HISTORIC AND DESIGN REVIEW COMMISSION

HDRC CASE NO: 2018-411
ADDRESS: 909 N PINE ST
LEGAL DESCRIPTION: NCB 531 (PINE AT HAYS {IDZ}), BLOCK 13 LOT 24
ZONING: IDZ, H
CITY COUNCIL DIST.: 2
DISTRICT: Dignowity Hill Historic District
APPLICANT: Ricardo Turrubiates/Terramark
OWNER: SA Urban Homes
TYPE OF WORK: Final approval for the Construction of a two story, single family residential structure
APPLICATION RECEIVED: October 12, 2018
60-DAY REVIEW: December 11, 2018
REQUEST:

The applicant is requesting a Certificate of Appropriateness for approval to construct a two story, single family residential structure on the vacant lot at 909 N Pine, located within the Dignowity Hill Historic District.

SITE PLAN

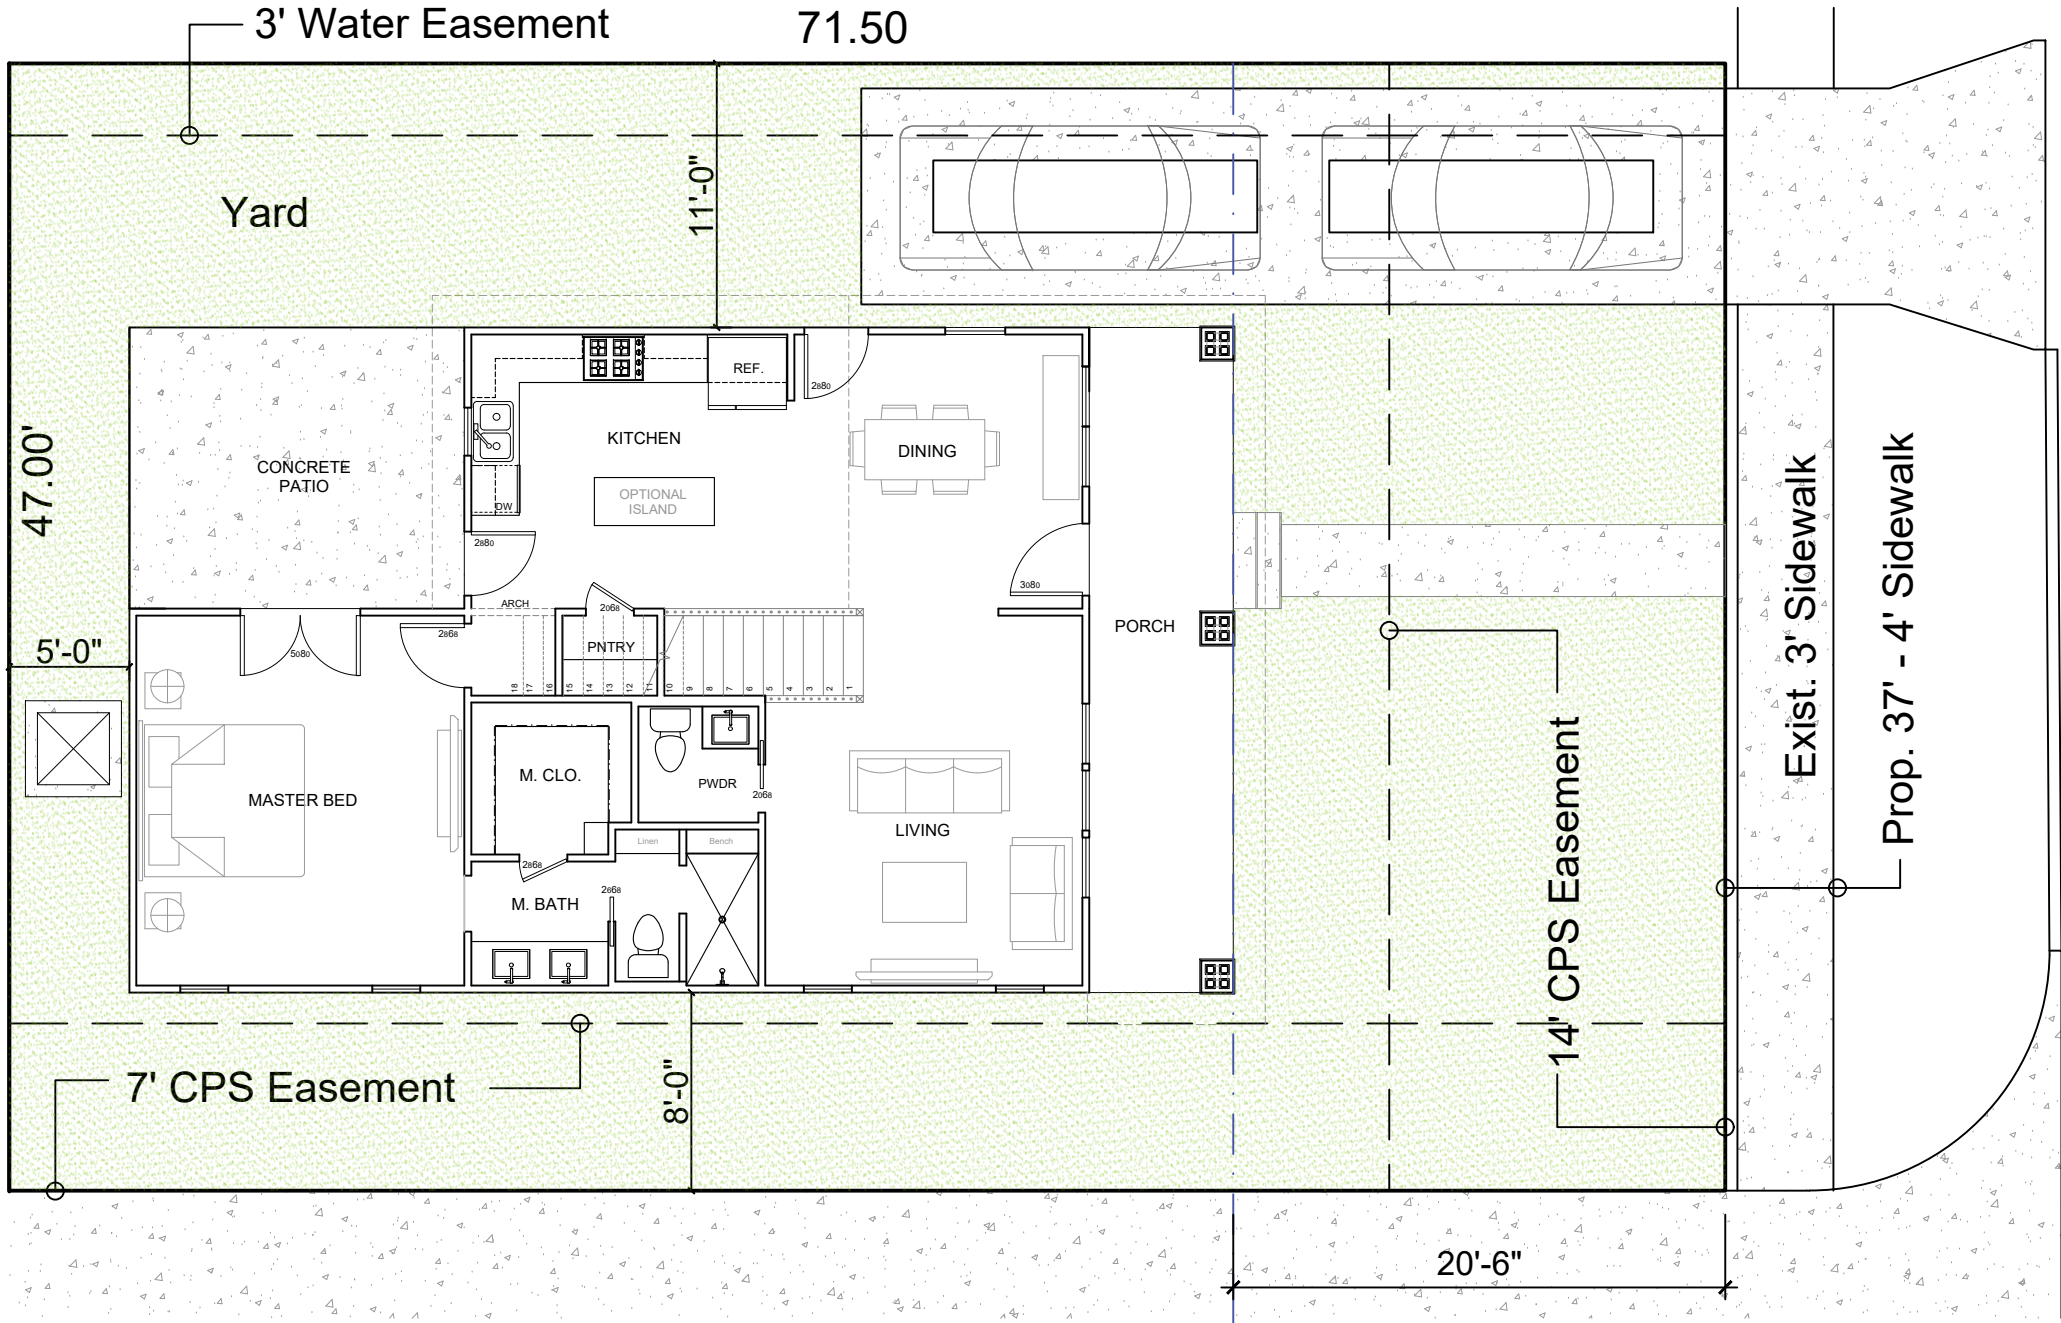
- i. That the applicant provide an accurate block survey noting correct setback measurements and confirmation that the proposed setback will be equal to or greater than all historic setbacks found on the block. **The applicant has provided an updated site plan noting a setback of 34' – 6" as well as the setbacks of neighboring structures on the block.**

- ii. That the proposed driveway width not exceed ten (10) feet in width and that the proposed front walkway not exceed four (4) feet in width. **The applicant has noted a driveway width of nine (9) feet in width and a sidewalk width of that is less than that found existing on site (approximately three feet in width).**

- iii. That a detailed landscape plan be submitted when returning to the HDRC for final approval. **The applicant has noted the location of turf and other site elements on the submitted site plan.**

- m. **DRIVEWAY** – The applicant has proposed a ribbon strip driveway to be located on the north side of the lot. This is consistent with the historic driveway location found on the block. The applicant has noted a width of nine (9) feet, consistent with the width.

- n. **SIDEWALK** – The applicant has proposed to increase the width of the existing, three foot sidewalk which runs parallel to the street to four (4) feet in width. The applicant has also proposed to install a front yard sidewalk to feature approximately three (3) feet in width. This is consistent with the Guidelines.

- o. **LANDSCAPING** – The applicant has noted on the submitted site plan the location of lawn area, sidewalks and the driveway. Any additional landscaping modifications should be submitted to OHP staff for review and approval.
